**Exhibition of Environmental Impact Statement for SSD-105396208
New Bankstown Hospital, Bankstown**

Submission to New Bankstown Hospital Environmental Impact Statement

Canterbury-Bankstown Council Submission
May 2026

Figure 1. Flood Study extract

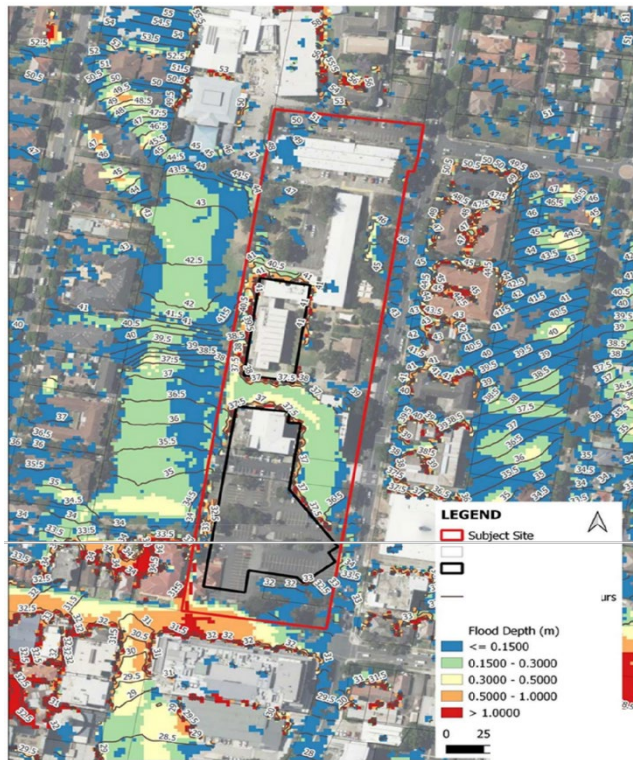
The submitted flood study states that the proposed hospital floor level of 32.05 m AHD achieves more than 500 mm freeboard above the Probable Maximum Flood (PMF), including climate change to 2090, and therefore would remain flood-free. However, Figure 22 of the flood report (extracted below) indicates PMF levels exceeding this elevation in areas surrounding the building footprint. This presents a potential inconsistency that requires clarification.

- Justification should be provided, or the modelling updated to ARR 2019 rainfall inputs.
- Clarification is requested on the terrain data sources used, and consideration should be given to updating the model using current LiDAR data, where available, to ensure consistency and reliability of results.
- Clarification is requested as to how roof runoff has been considered in flood behavior and stormwater management modelling.
- Clarification of the PMF levels is required.
- Consideration to be given to alternate access/egress options should French Avenue be inundated during a 1% AEP event.
